CITY OF WICHITA

October 27, 2004

RE: **BZA2004-00077: Sign Code Adjustment to reduce the spacing between a proposed new sign and an existing sign located to the west from 150 feet to 133 feet.**

Legal Description: Reserve C, Ken-Mar Addition, Wichita, Sedgwick County, Kansas. Located at the northwest corner of 13th Street North and Oliver.

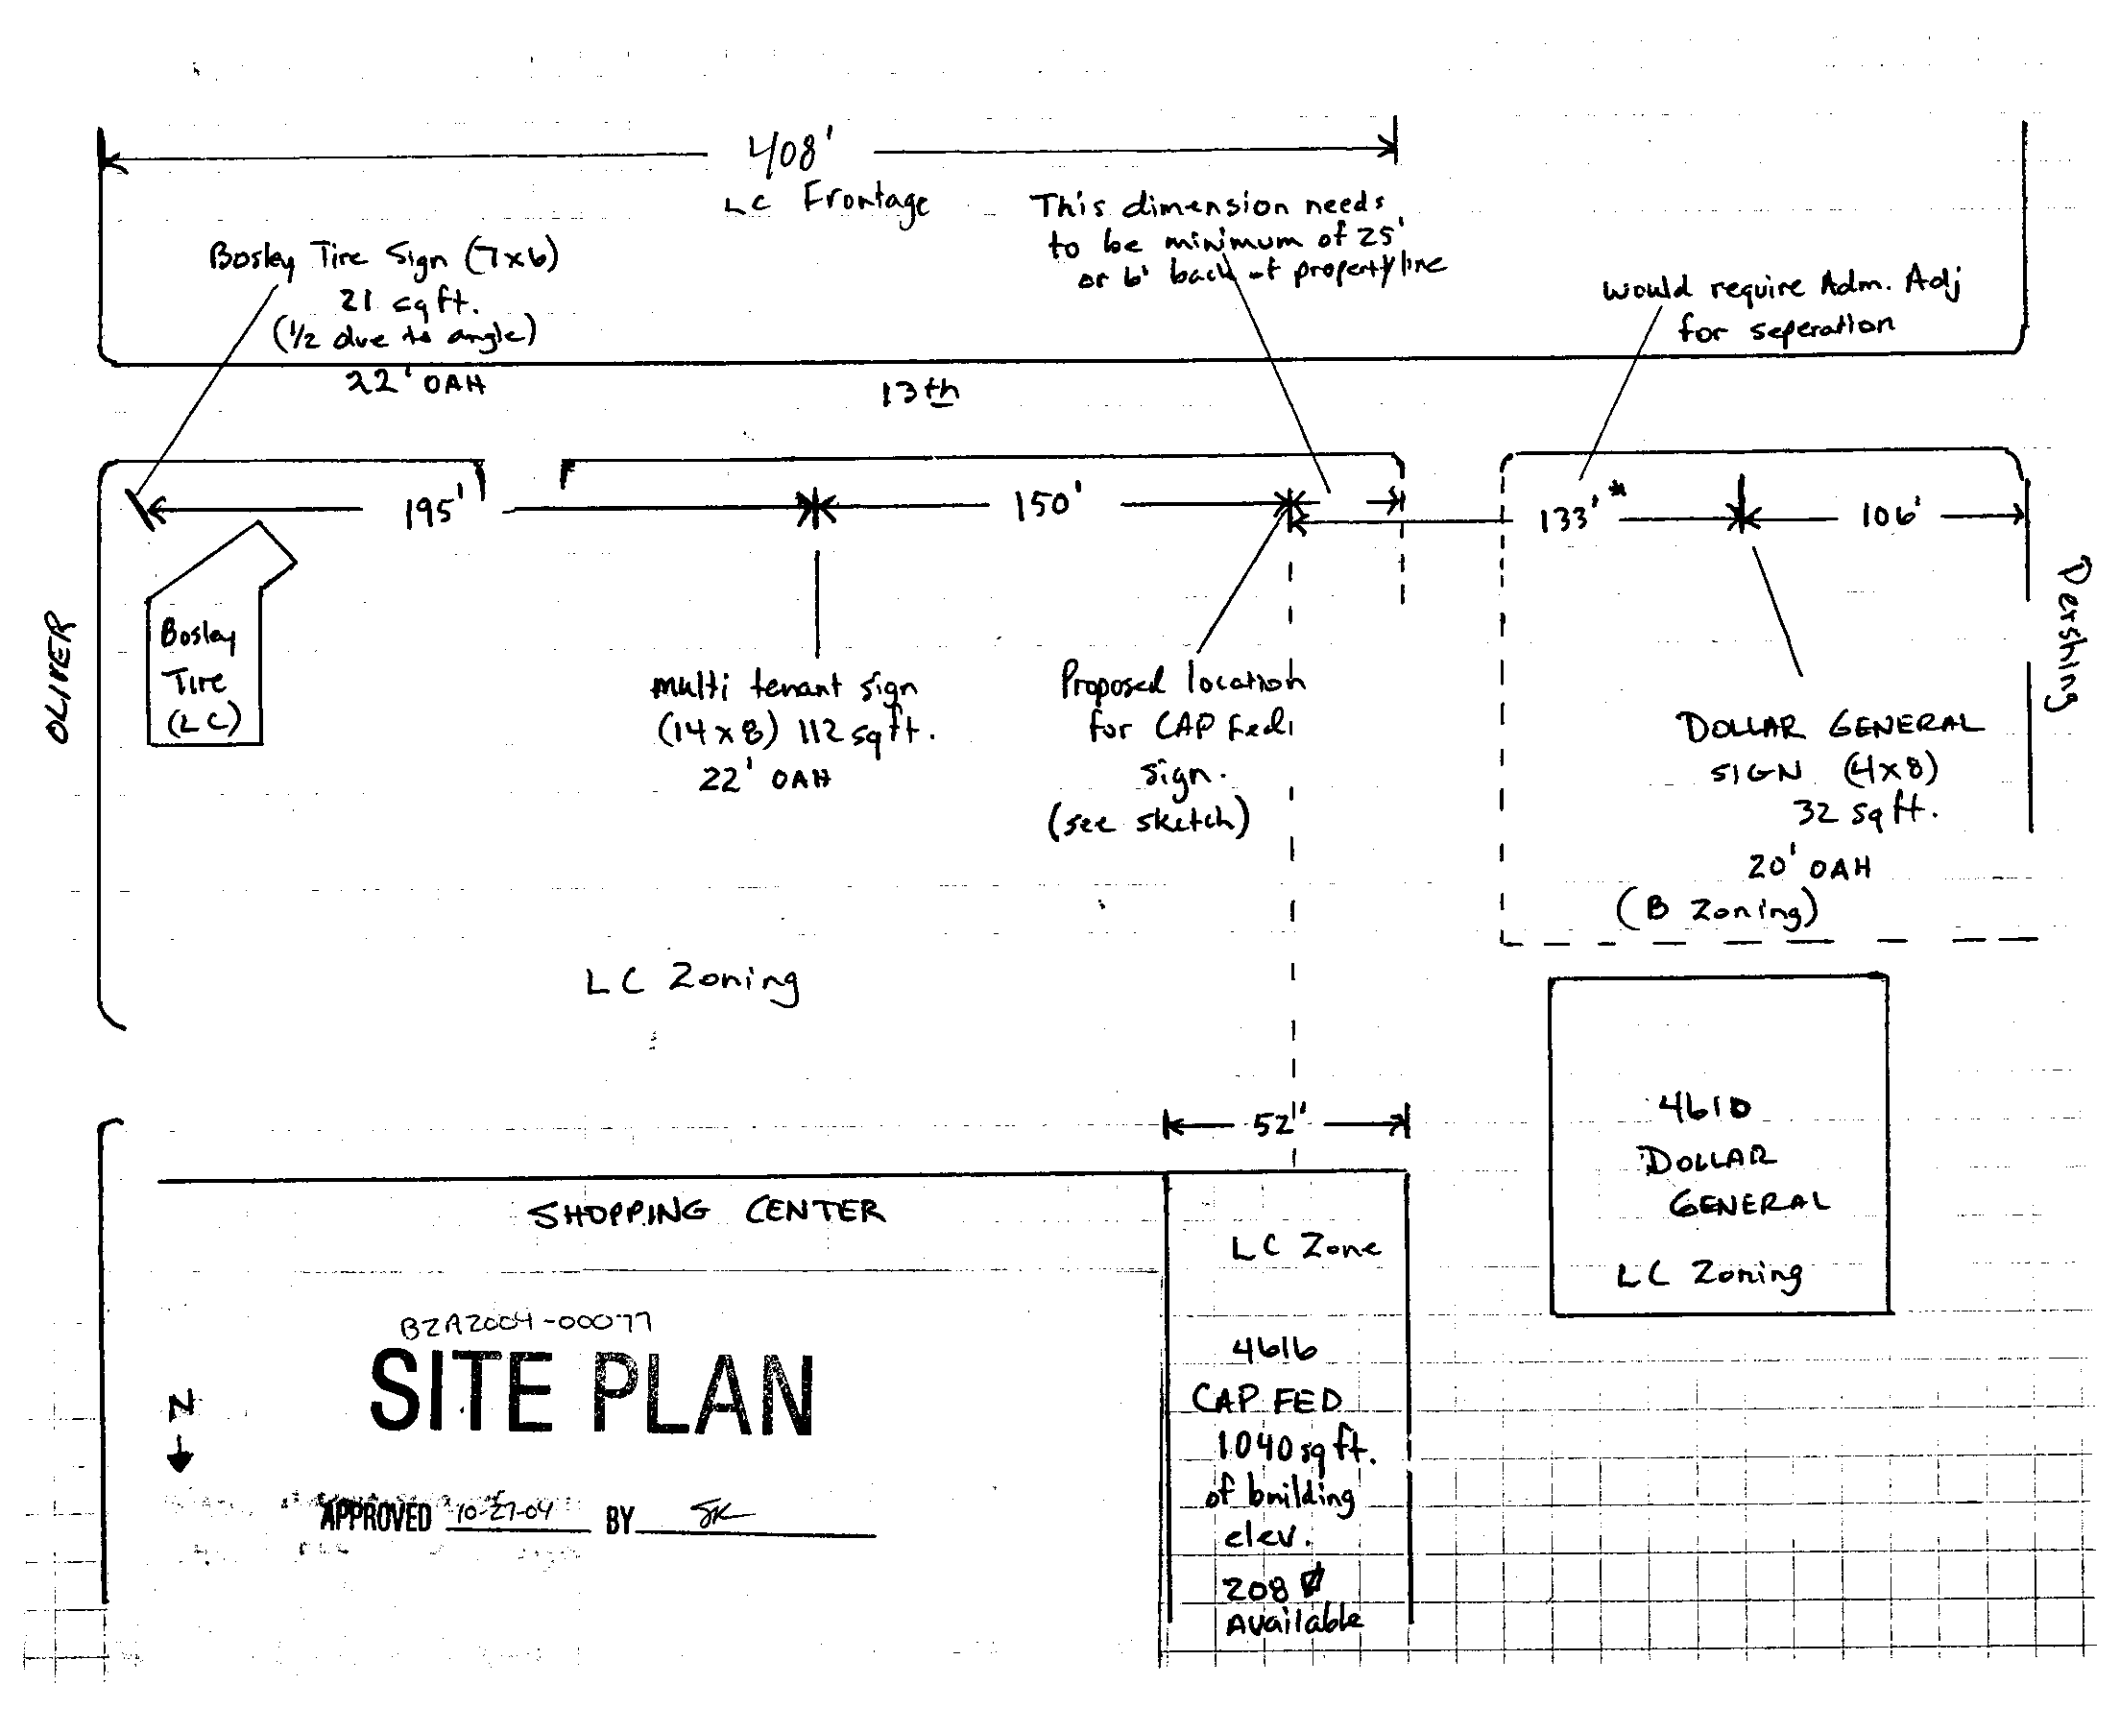
408'
LC Frontage
This dimension needs to be minimum of 25' or 6' back of property line
Would require Adm. Adj for seperation
Bosley Tire Sign (7x6)
21 sq ft.
(1/2 due to angle)
22' OAH
13th
195'
150'
133'*
106'
OLIVER
Pershing
Bosley Tire (LC)
multi tenant sign (14x8) 112 sq ft.
22' OAH
Proposed location for CAP Fed sign. (see sketch)
DOLLAR GENERAL SIGN (4x8)
32 sq ft.
20' OAH
(B Zoning)
LC Zoning
52'
4610 DOLLAR GENERAL
LC Zoning
SHOPPING CENTER
LC Zone
4616 CAP FED
1040 sq ft. of building
elev.
208' Available
BZA2004-00077
SITE PLAN
N
APPROVED 10-27-04 BY

We have reviewed your request for a Sign Code Adjustment to reduce the spacing between signs on the aforementioned property. From reviewing your application, we understand that you propose to construct a monument sign along Oliver. While the property has sufficient frontage along Oliver to permit the proposed size and height of the sign, the existing signs on the property are spaced such that the proposed new sign cannot be placed along Oliver and maintain the required 150 feet of separation from other signs. Therefore, you have requested an adjustment to reduce the required spacing between the proposed new sign and the existing sign located to the west from 150 feet to 133 feet.

Our signatures below indicate that a Sign Code Adjustment to reduce the spacing between a proposed new sign and an existing sign located to the west from 150 feet to 133 feet on the aforementioned property is hereby granted, subject to the following conditions:

1) The proposed new sign shall be installed in the location indicated on the approved site plan with a minimum spacing of 133 feet between the proposed new sign and the existing sign located to the west.

2) The proposed new sign shall be monument style and shall be limited to 20'6" in height and 193 square feet in size.
